ADDENDUM NO. 01

Project Name: TFSD 2023 Capital Improvements
Address: Twin Falls, Idaho

Date Issued: March 18, 2024

Addendum No. 01

Sheet P2.11 – LEVEL 1 WASTE & VENT PLAN

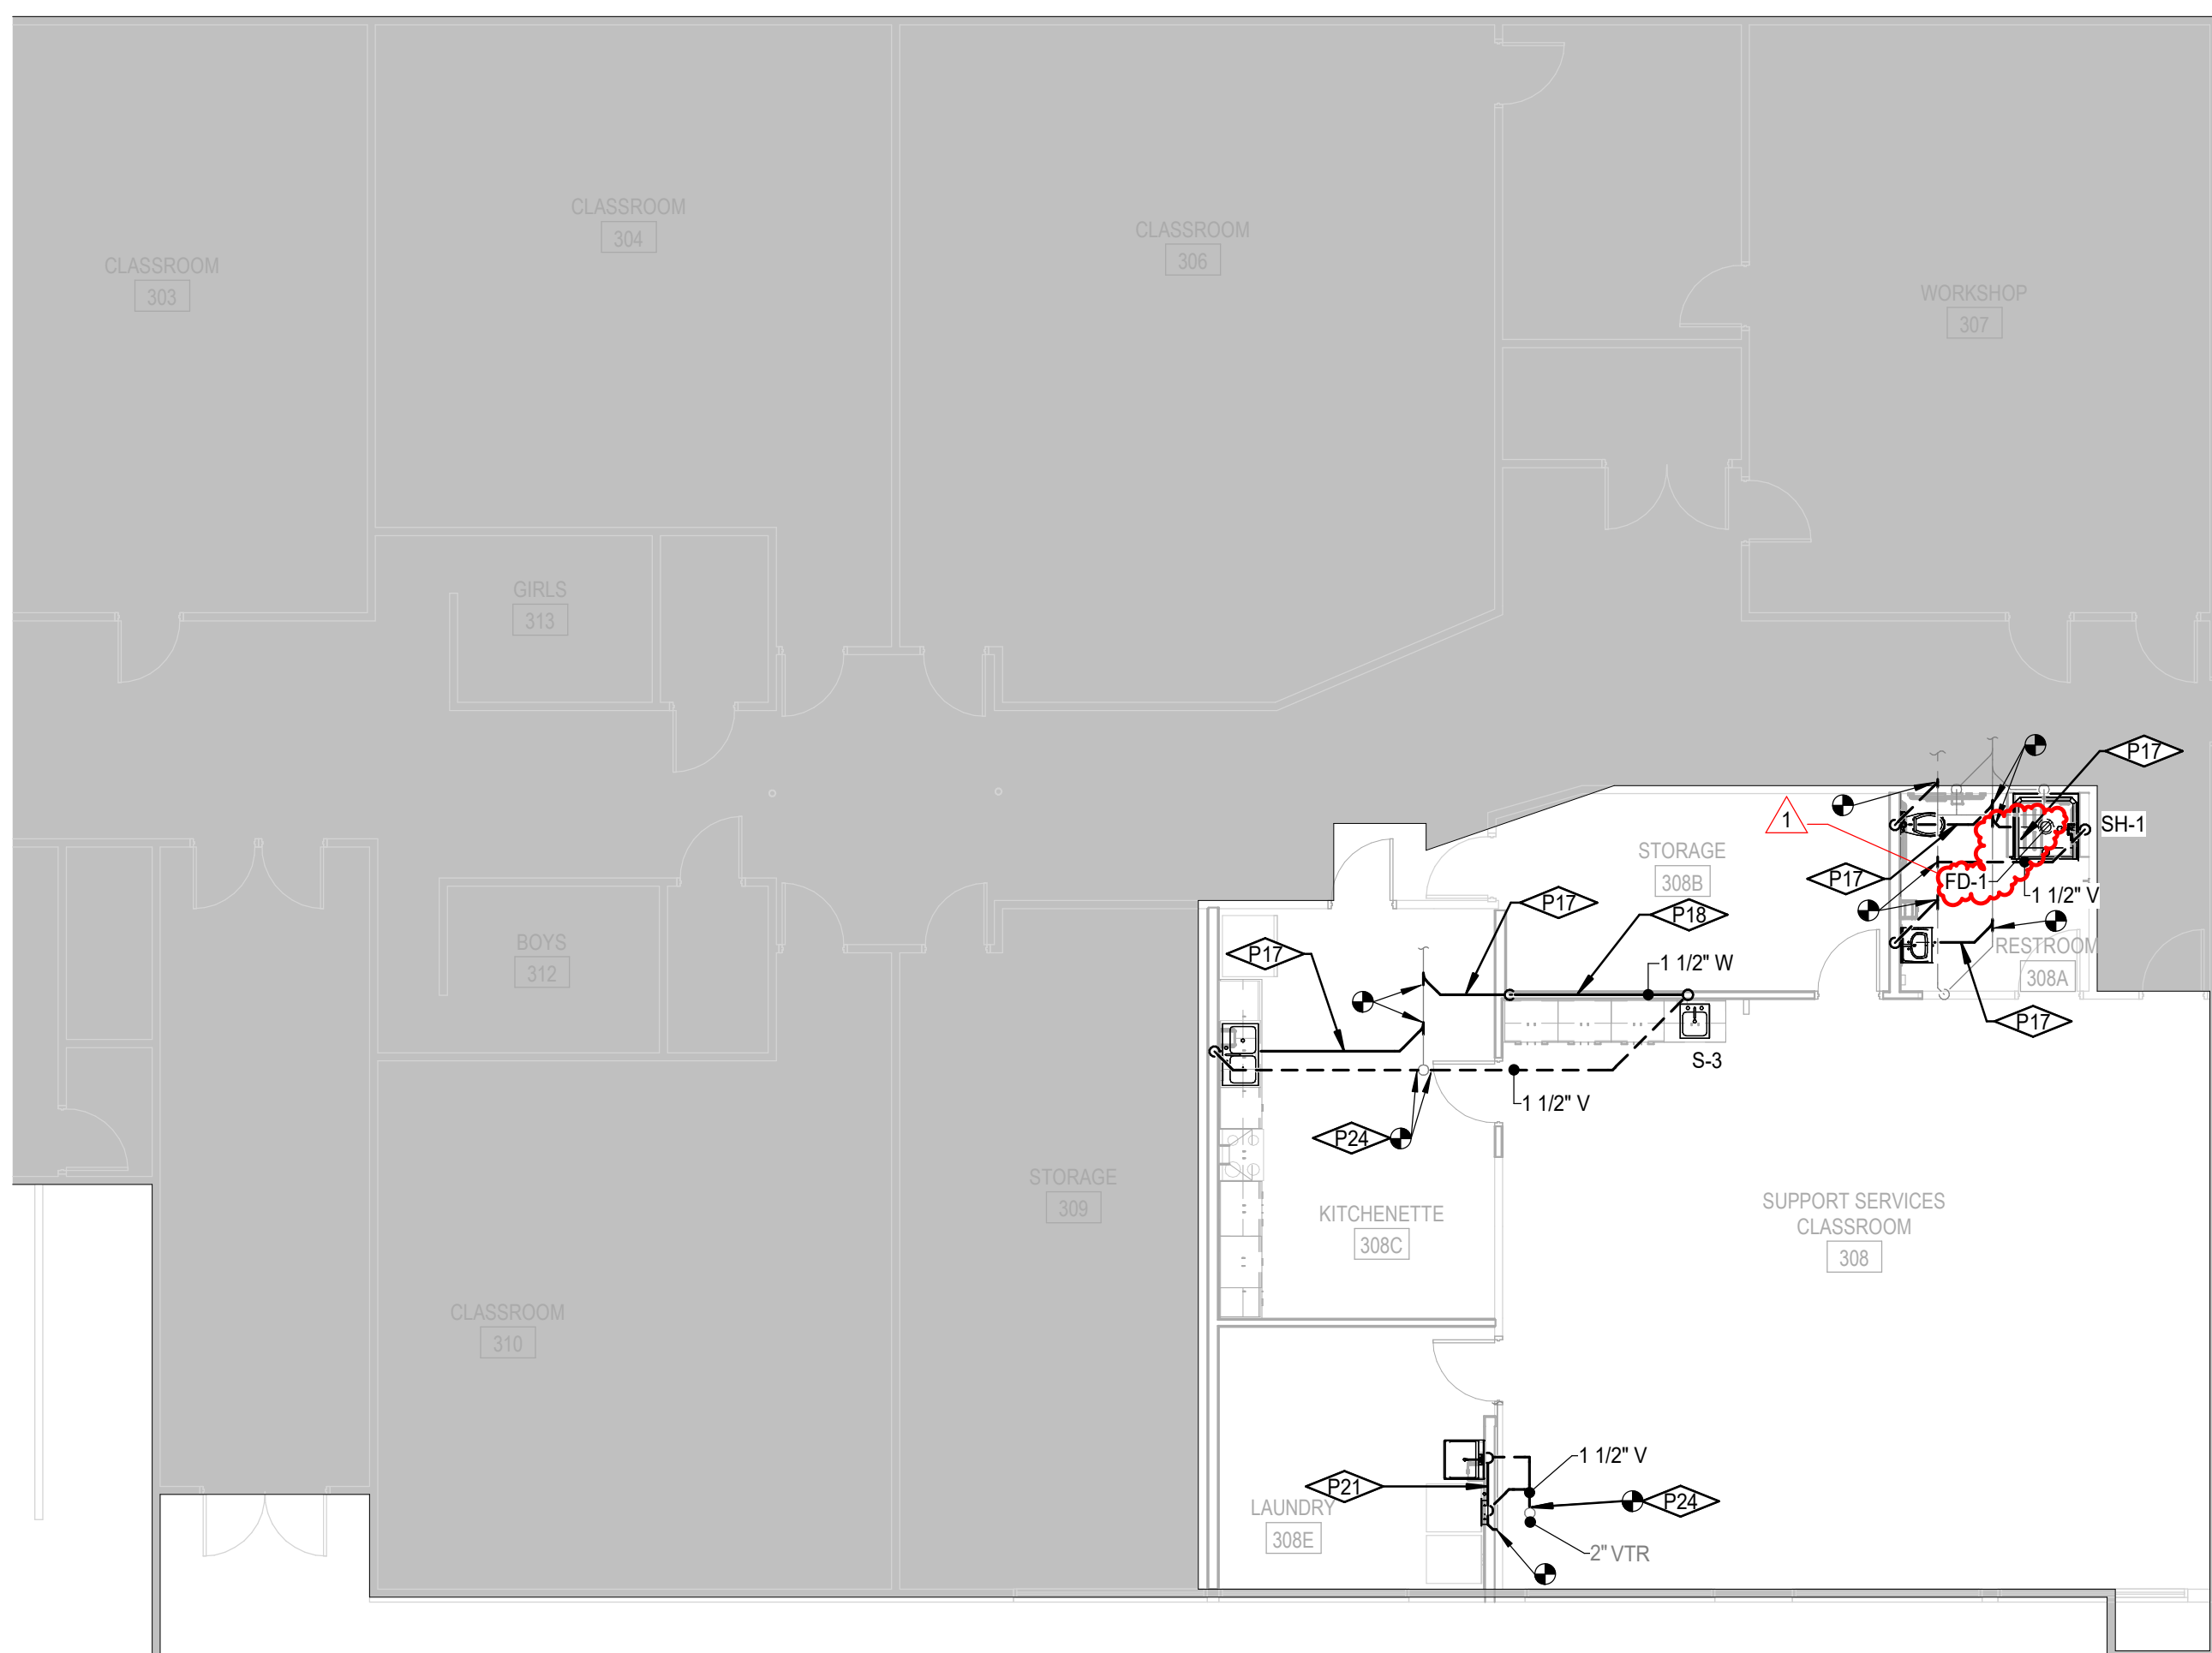
- **Response to RFI Question 3: Shower P0.01**
Question: Verify that per the specifications the shower in Robert Stuart will be a fiber glass per spec section 224000-6 I- Pre-Fab Shower is correct. Also is there suppose to be a drain under this shower, nothing really shown per P2.01?

Response: See attached revised Plumbing drawings indicating tiled shower with trim and drain provided in updated plumbing fixture schedule. Pre-fab shower insert is not included in this scope of work.

Sheet A2.01 – RESTROOM REMODEL PLANS & ELEVATIONS

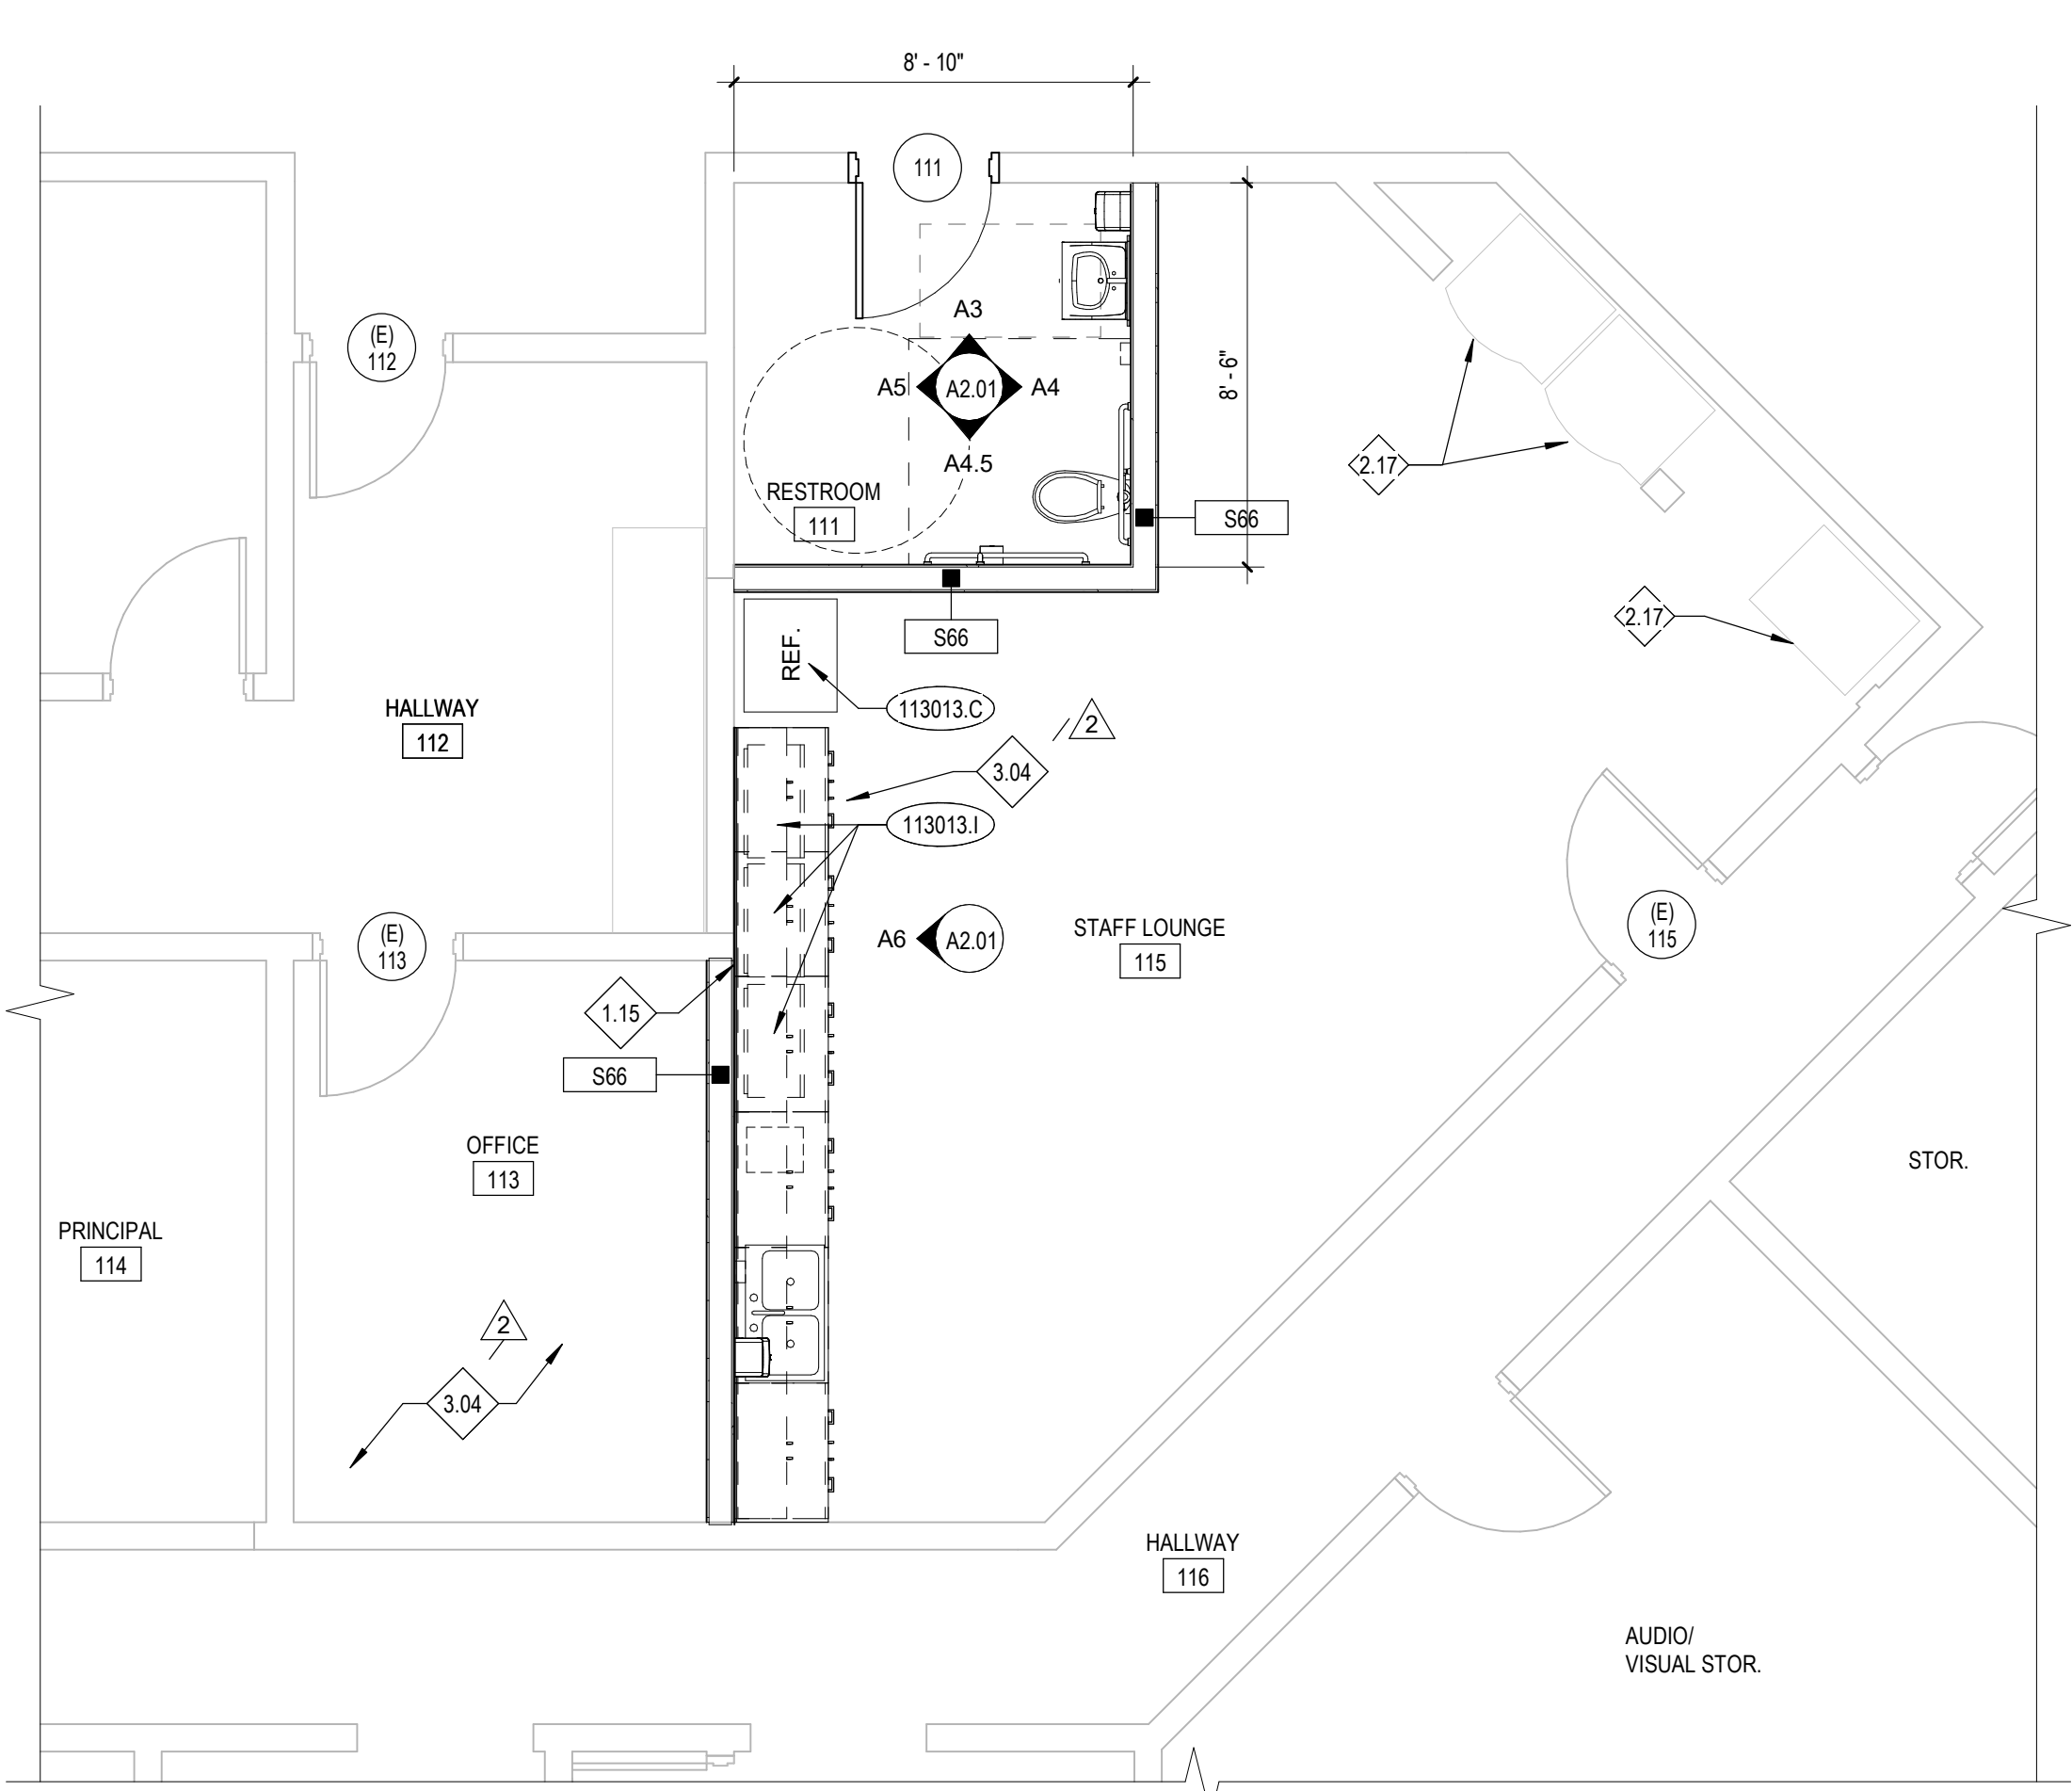
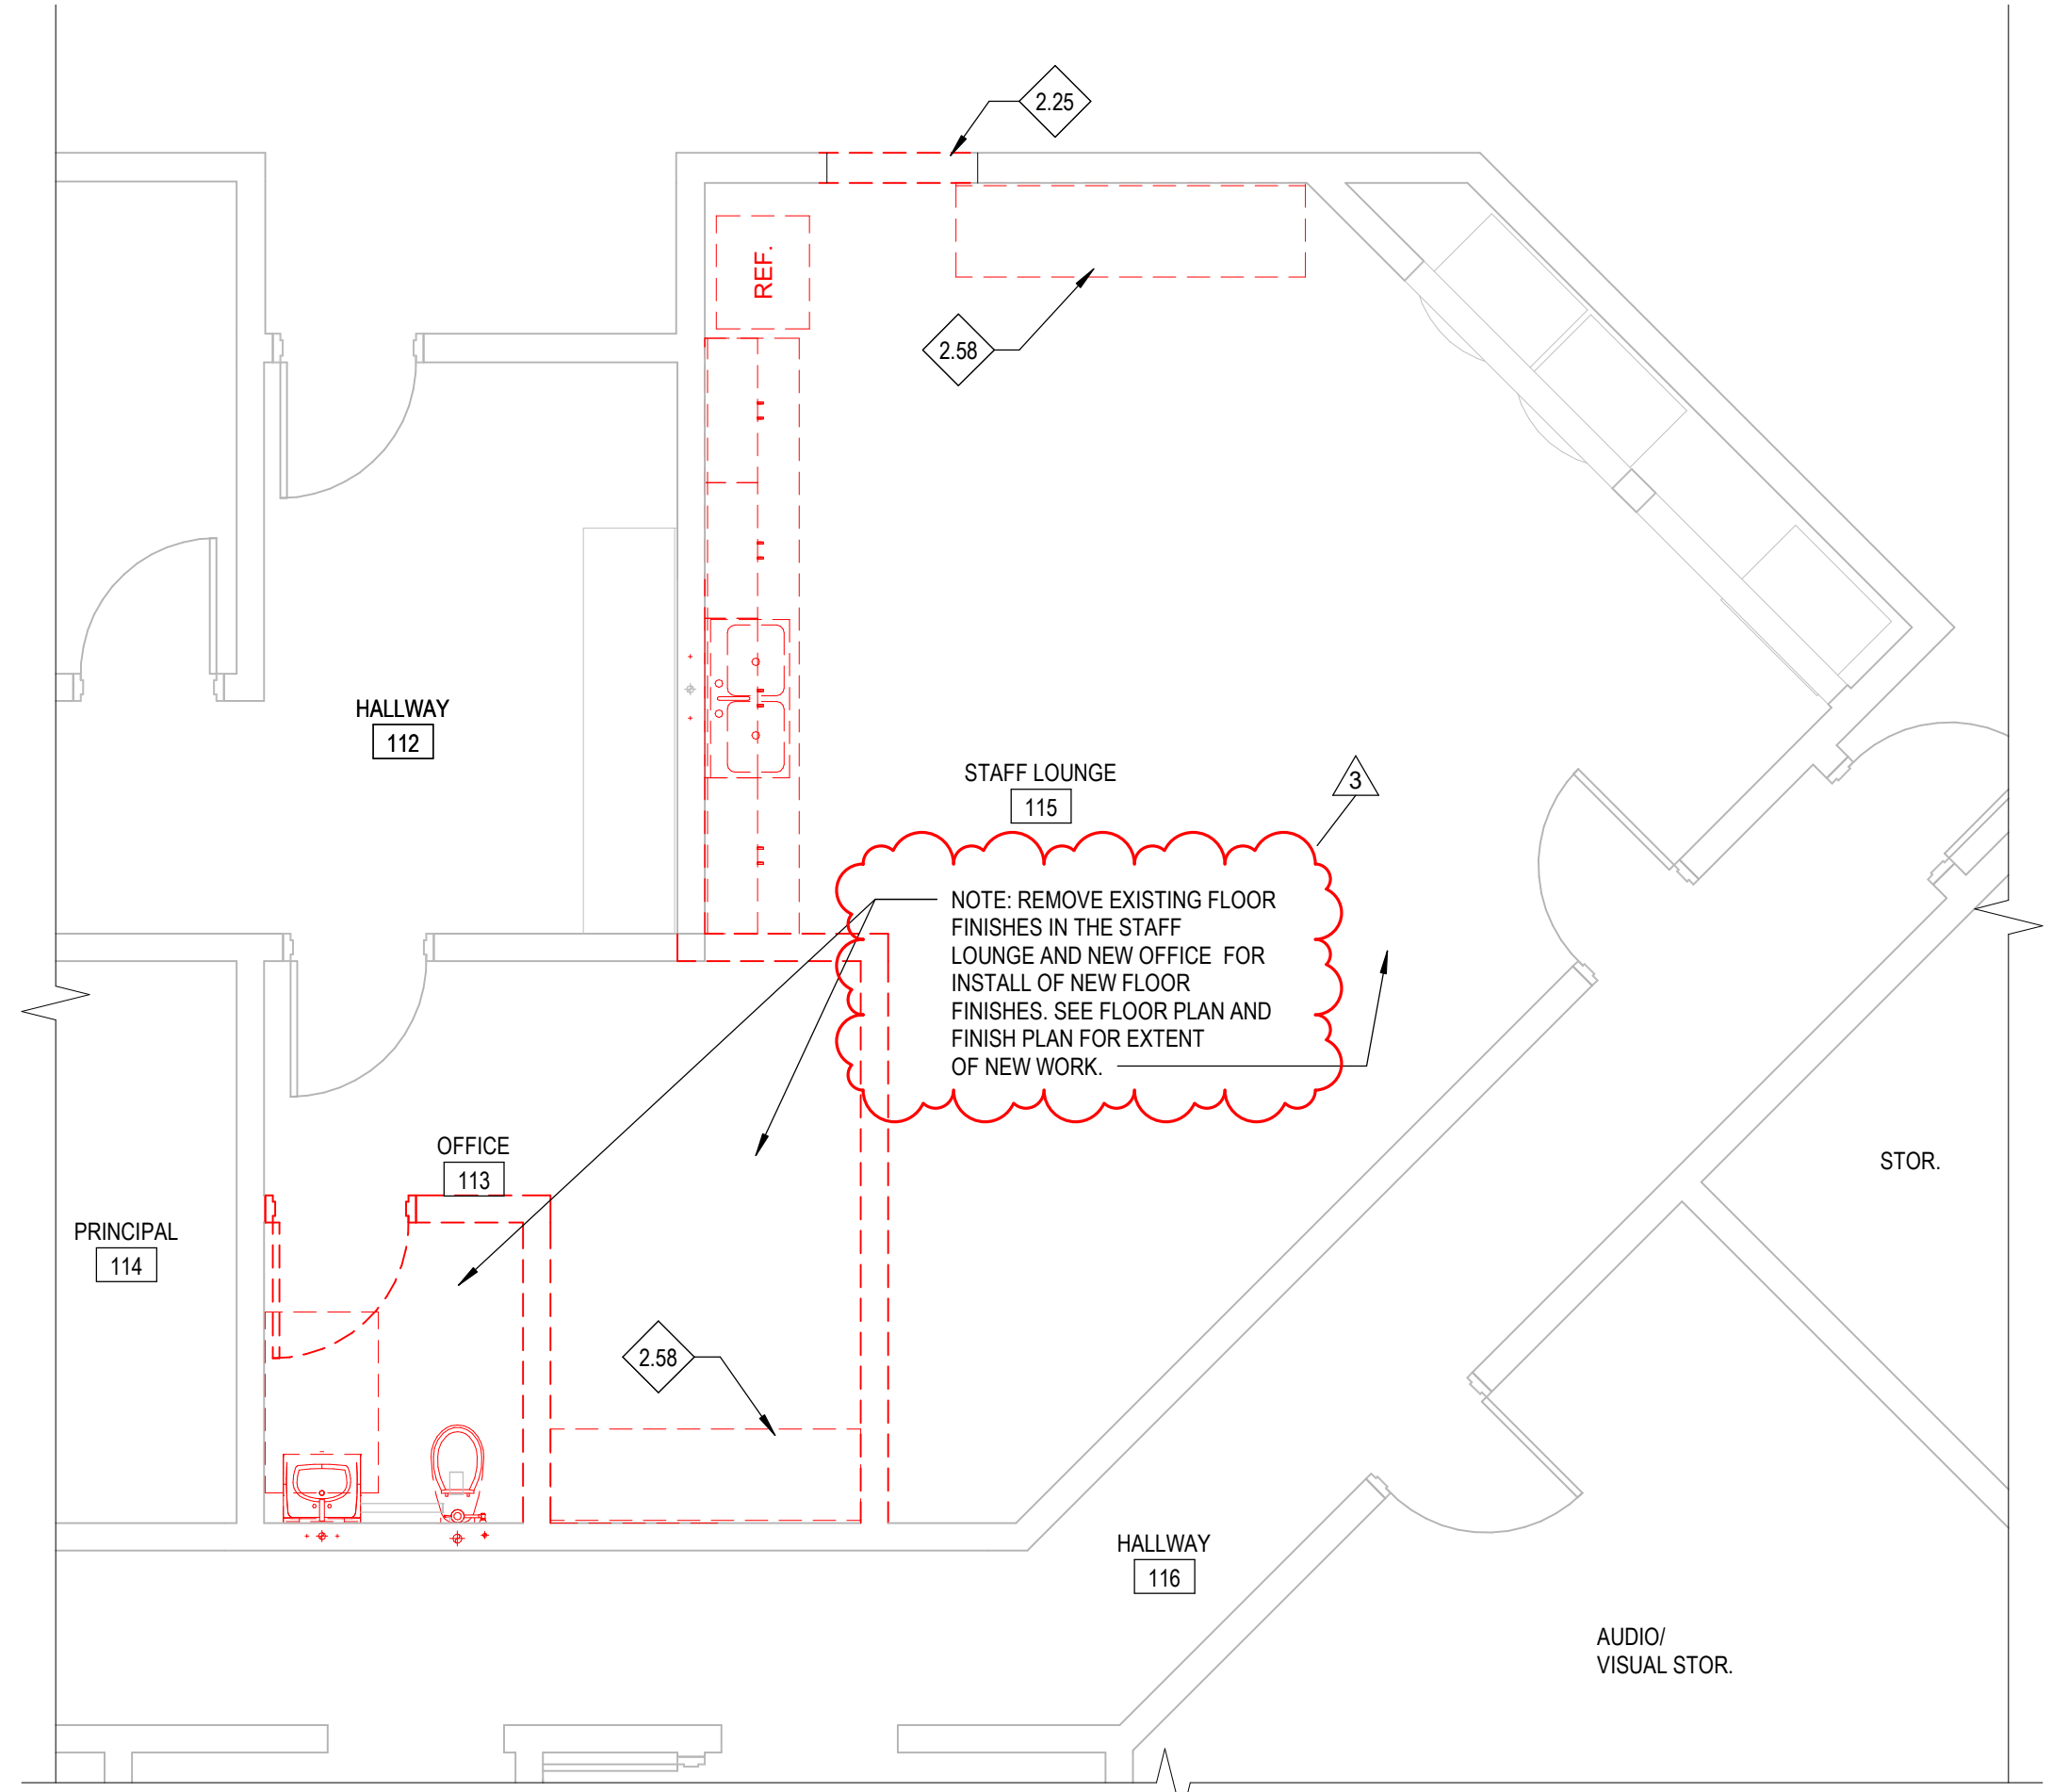
Question: O'Leary and Robert Stuart plan sheets A2.01 & A2.02 does not have a call out for the floor existing floor finishes. We would assume under all new flooring old tile or carpet to be removed? Also, is there a asbestos survey for the O'Leary, Robert Stuart, Morningside & Harrison, that we could obtain.

Response: See attached revised sheets for demo of existing floor finishes at Robert Stuart and O'Leary Middle Schools. See response from Construction Manager for materials testing report.
